JAN 06 1994

MEMORANDUM FOR: Lawrence C. Shao, Director
Division of Engineering, RES

FROM: Andrew J. Murphy, Chief
Structural and Seismic Engineering Branch
Division of Engineering, RES

SUBJECT: SUMMARY OF A PUBLIC MEETING ON THE REVISION OF APPENDIX A
"SEISMIC AND GEOLOGIC SITING CRITERIA FOR NUCLEAR POWER
PLANTS" TO 10CFR PART 100

ILLUSTRATION OF THE PROCEDURE TO ESTIMATE THE SSE GROUND MOTION

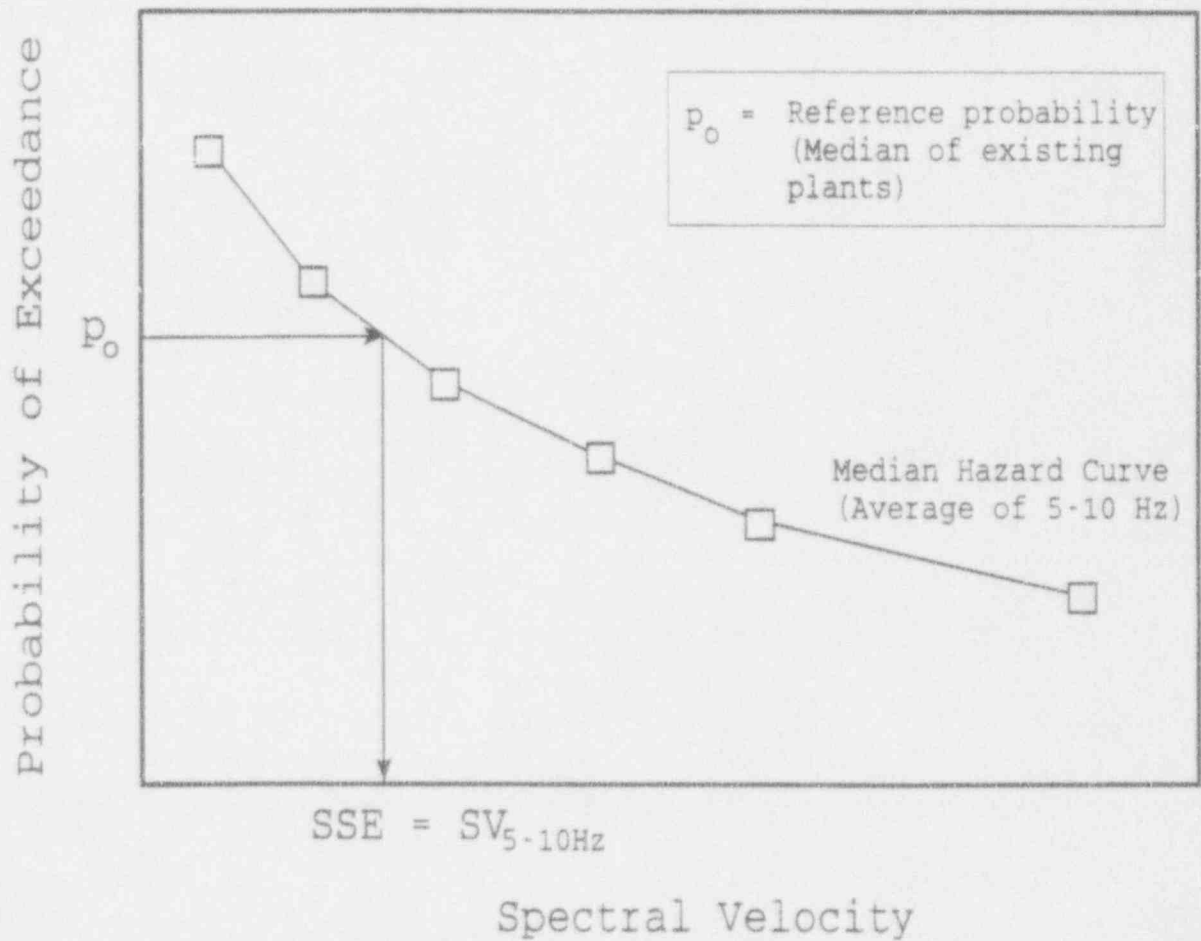
(3) NRC requested the basis, in the form of results from numerical calculations, to support NUMARC's recommendation that scaling the effective ground motions to the reference probability is the appropriate method to derive the SSE ground motions in place of the NRC staff's method of using SRP 2.5.2, which results in about the 84th percentile. NUMARC was asked to determine the fractiles that result from using its method. The Staff's consultants suggested several schemes for investigations to adjust the magnitudes and distances of controlling earthquakes to implement the fractile required by SRP 2.5.2, and at the same time keep it compatible with scaling to the reference probability level. The staff is performing some of these calculations. NUMARC was also informed that the staff was considering using the median of plants designed to R.G. 1.60 or similar spectra for the reference probability, and that NUMARC may find the calculations based on this choice useful. The staff suggested that it may also be instructive to perform these calculations by deaggregating both mean and median hazard curves as the NUMARC and the staff proposed approach differ in this area.

BASIS AND DEMONSTRATION

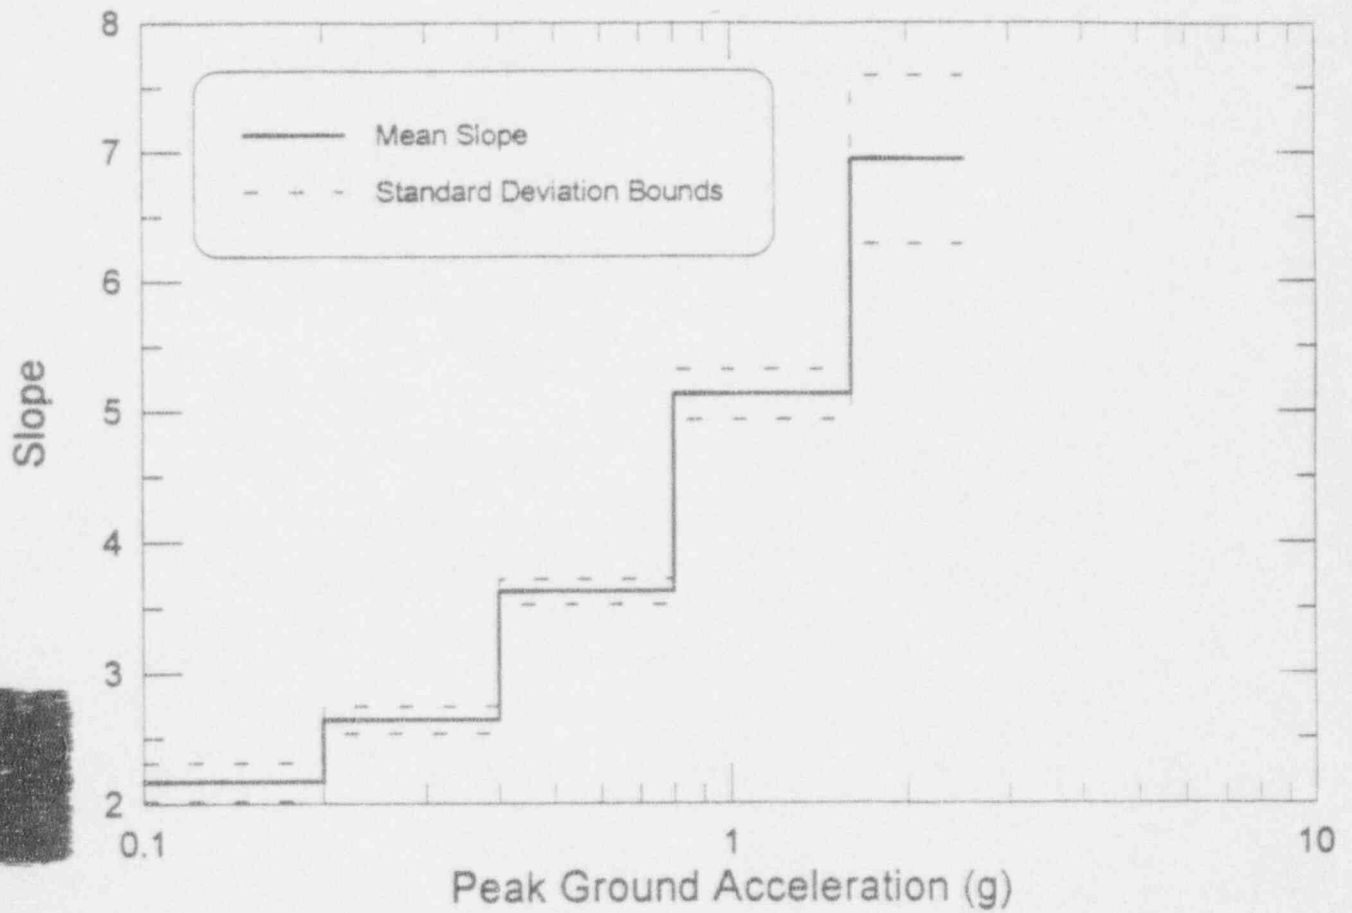
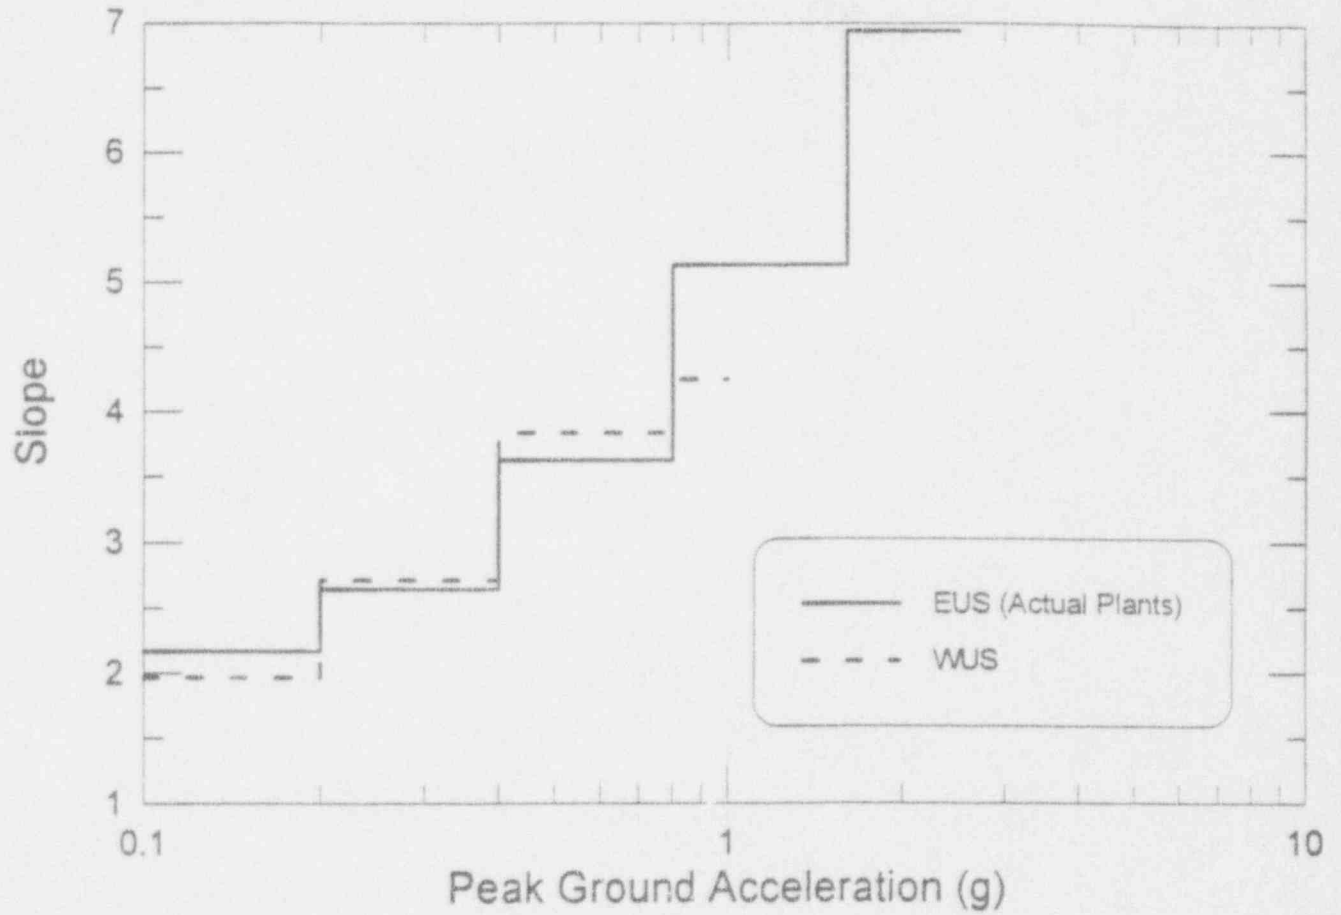
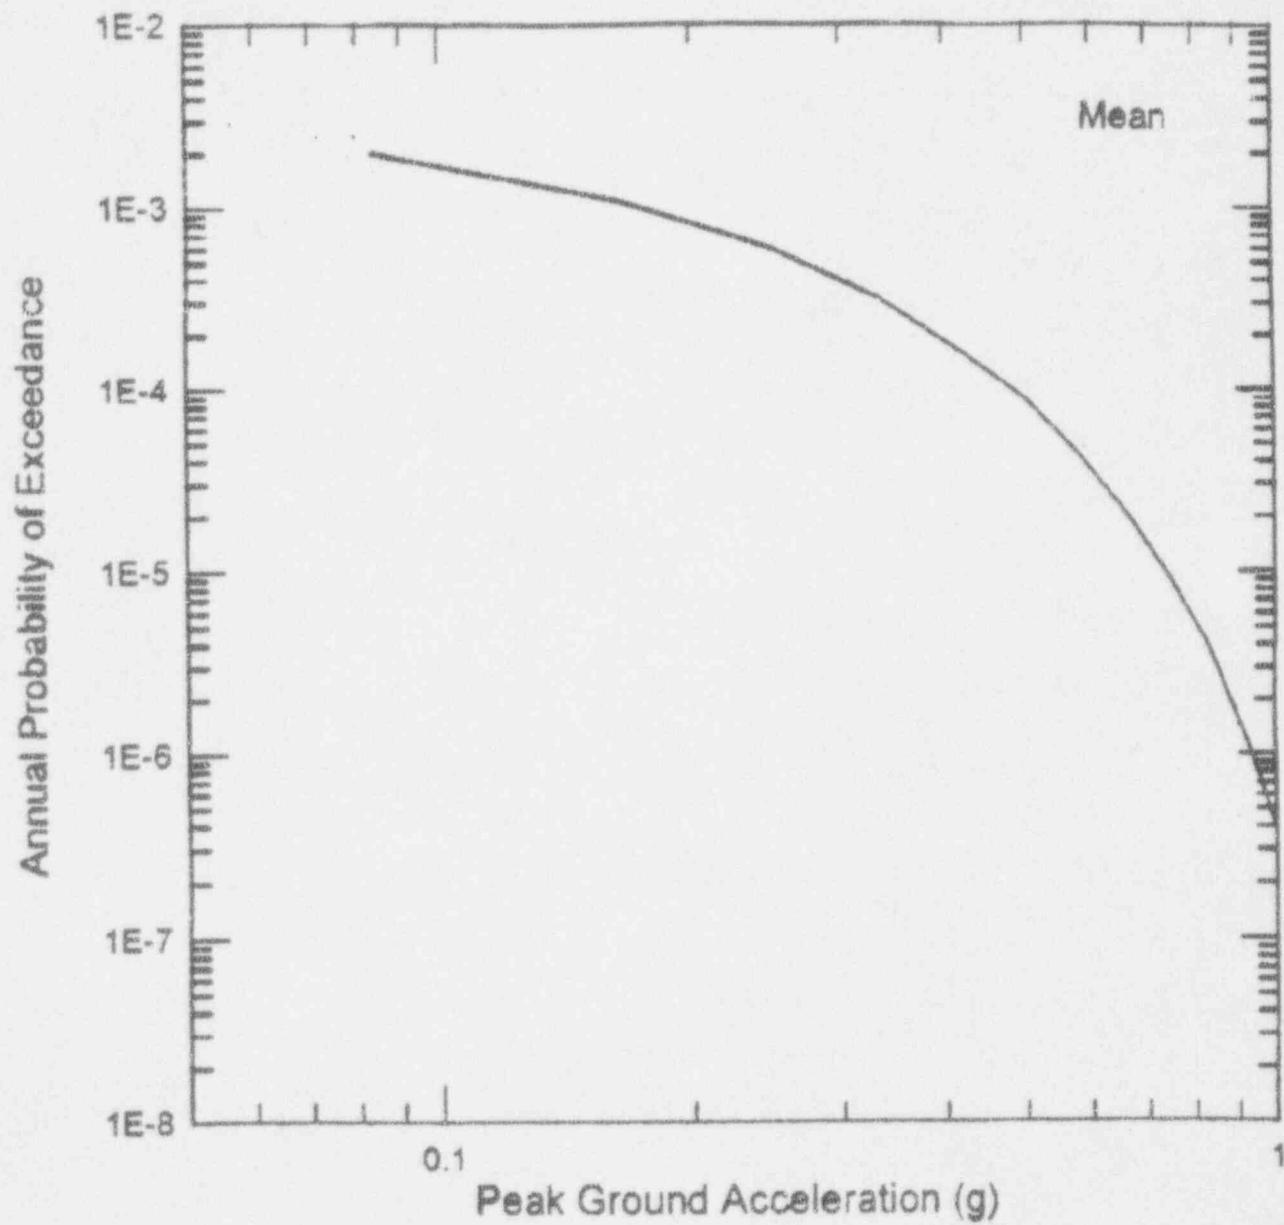
(5) Finally NUMARC was told that the presentation that demonstrated the way in which the reference probability may be adjusted for application to a site in the western U.S. located near a fault on which the controlling may occur, needs to be documented with the hazard curves on which it is based and a much stronger writeup description. It is the staff's understanding that the database was obtained from various DOE installations and petroleum company facilities. The staff needs to examine at least a representative part of that database.
